**Subject: MHI's Amended Response to US-APWR DCD RAI No. 374-2446 Revision 0 (SRP 03.09.05)**

Amended Response to Request for Additional Information  
No. 374-2446 Revision 0

**RAI NO.:** NO. 374-2446 REVISION 0  
**SRP SECTION:** 3.9.5 – REACTOR PRESSURE VESEL INTERNALS  
**APPLICATION SECTION:** 03.09.05  
**DATE OF RAI ISSUE:** 5/21/2009

**QUESTION NO.: 03.09.05-10**

Figure 3.9-9 Neutron Reflectors

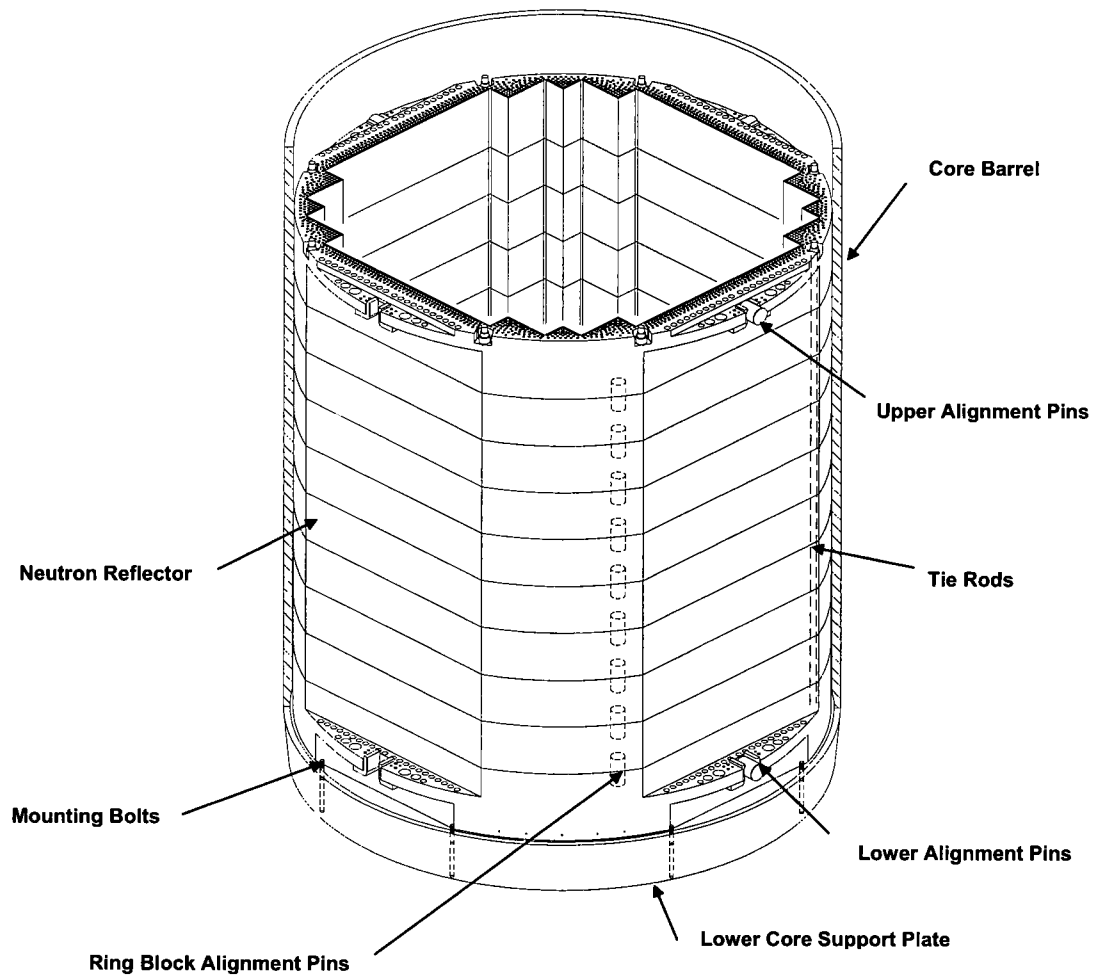
The DCD Tier 2, Subsection 3.9.5.3.4 includes the potential effects of irradiation stress relaxation in the list of environmental effects on reactor core internal materials caused by long term exposure to fast neutron irradiation. The applicant stated that neutron fluence and temperature limits are imposed on the tie-rods to preclude excessive loss of preload from irradiation stress relaxation.

The staff reviewed the DCD but did not find where the applicant had provided an evaluation of the loss of preload in various threaded fasteners due to irradiation stress relaxation or a reference where this information is available. The applicant did not identify the fasteners where the effect of irradiation stress relaxation is expected to be significant. Also, it is not clear how the pre-stress will be maintained in the preloaded components such as the ring block tie-rods or guide tube hold-down bolts. The applicant is requested to provide an assessment of the potential loss of preload due to irradiation stress relaxation in various threaded fasteners, in particular the guide tube hold-down bolts, guide tube support pins and the flexible leaves, and the neutron reflector tie-rods, and examine its effect on the structural and functional integrity of the components. Alternately, provide a reference document where this information is available. The requested information will assure conformance with GDC-1 and 4. Revise the DCD to include the requested information or provide a reference where this information is available.

Figure 3.9-9 shows the neutron reflector assembly, which offers a significant reduction in the number of threaded fasteners, and an improvement in neutron reflectivity, from the

~~design of currently operating PWR plants. The neutron reflector consists of multiple stacked ring blocks that which are supported mounted on the lower core support plate in the vertical downward direction by the lower core support plate and by tie rods and neutron reflector mounting bolts in the vertically upward direction.~~

Vertical restraint for upward mechanical loads is provided by tie-rods and neutron reflector mounting bolts. The tie-rods are captured by a nut bearing on the top ring block. The tie-rods pass through holes in the blocks and are threaded into the lower core support plate. Fluence and temperature limits are also imposed on the tie-rods to preclude excessive loss of pre-load from irradiation relaxation. In addition, the bottom ring block is fastened directly to the lower core support plate by the mounting bolts. Ring blocks, excluding the bottom ring block, can be held down by their own weight in normal operating conditions, including design transients. During seismic and LOCA events, the lift-off displacement is restricted by the tie rods.
